**From:** Lance Doyle  
**Sent:** 12/07/2024 10:50:15 PM  
**To:** Council Northernbeaches Mailbox  
**Subject:** TRIMMED: DA 2024/0774 - CONSTRUCTION OF A DWELLING HOUSE INCLUDING SWIMMING POOL Address: 6 MITCHELL ROAD PALM BEACH  
**Attachments:** SUBMISSION TO COUNCIL RE 6 MITCHELL ROAD.pdf;

**Re DA 2024/0774 - CONSTRUCTION OF A DWELLING HOUSE INCLUDING SWIMMING POOL**

**Address: 6 MITCHELL ROAD PALM BEACH**

**ROCK FACE AT REAR OF 17 FLORIDA ROAD SHOWING  
ROCK PILE AT TOP OF THE CLIFF**

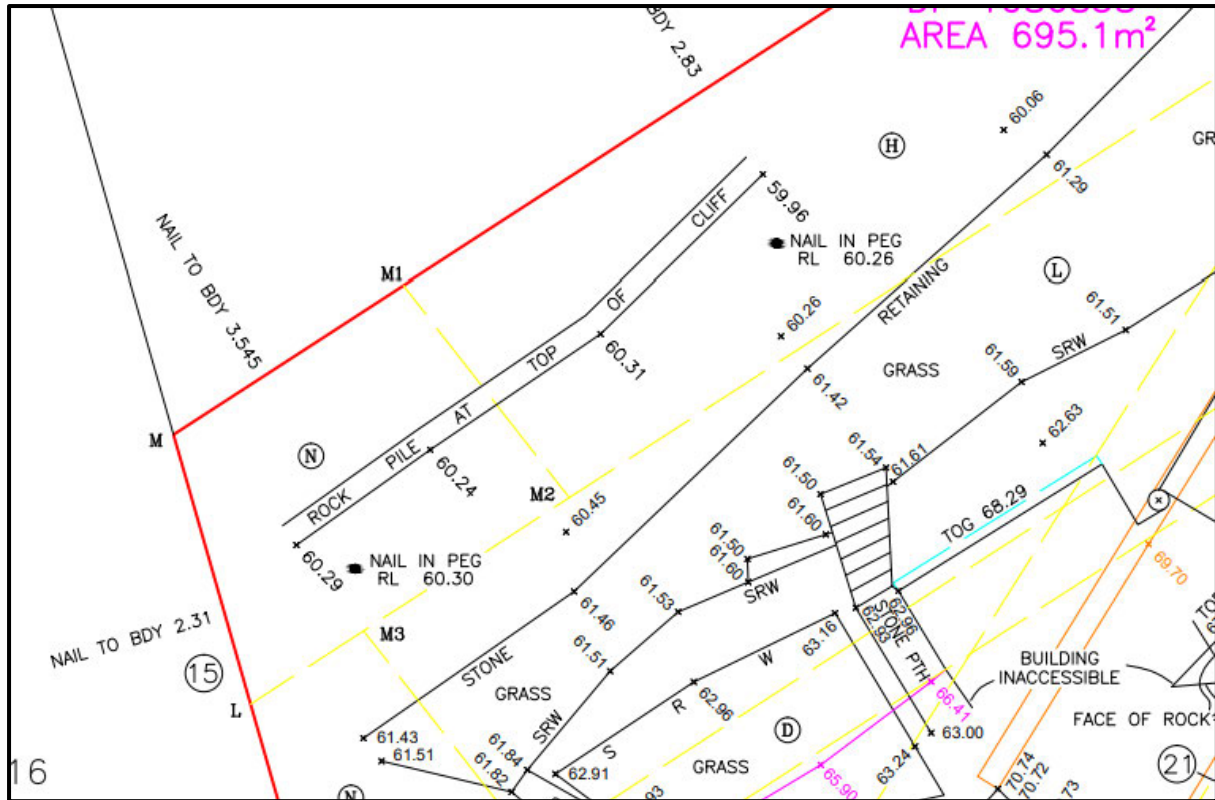
Firstly, and the most important issue for my client is the potential damage to property or persons located within 17 Florida Rd as a consequence of the unstable rocks and other material migrating off site and on to my client's site.

The following photograph taken from the rear of 17 Florida Road illustrates the height of the "cliff" and the location of the rock pile at the upper part of the rock face.

The submitted survey report also identifies the area of concern as “ROCK PILE AT TOP OF CLIFF”. The location at the top of the cliff confirms the potential magnitude of any movement of the rock pile.

It is therefore requested that Council direct the applicant to further engage the services of the Geotechnical engineer responsible for identifying the geotechnical hazards and recommend a scope of works to render the entire site able to be deemed "acceptable" and if this is not achievable, the DA be refused and the site rendered safe in terms of unstable components.

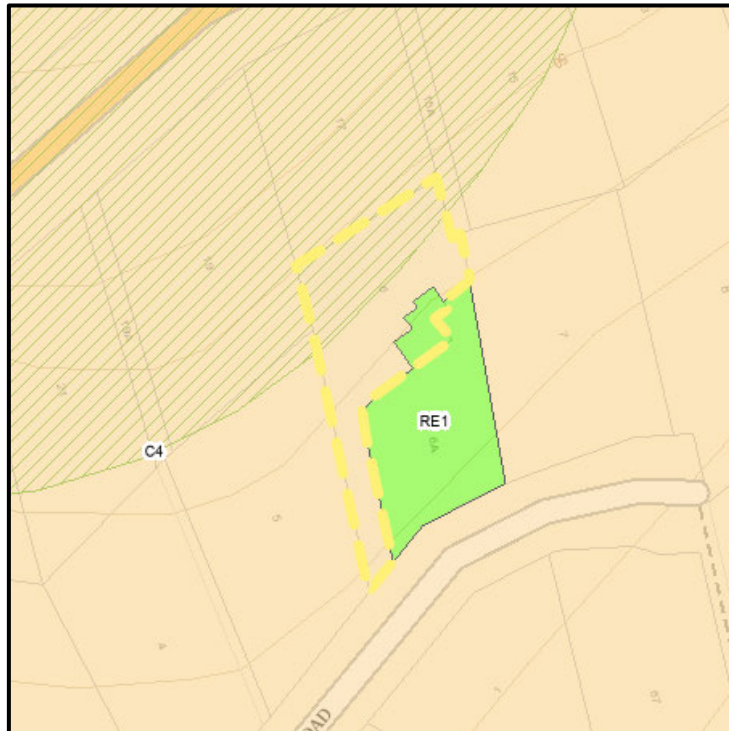
The submitted landscape plan, both in plan view and section, does not provide adequate details of any landscaping between the northern elevated edge of the pool and the common boundary with 17 Florida Rd.

This aspect of the proposal is concerning for two reasons, firstly likely overlooking into the rear living areas of 17 Florida Rd and secondly the necessity to screen the undercroft area in accordance with Section D12.13 of the DCP which states -

*Undercroft areas shall be limited to a maximum height of 3.5 metres.*

*Adequate landscaping shall be provided to screen undercroft areas.*

It is therefore requested that an amended landscape plan be provided to satisfy the concerns of my client and also the necessity for compliance with the above provisions of the DCP.
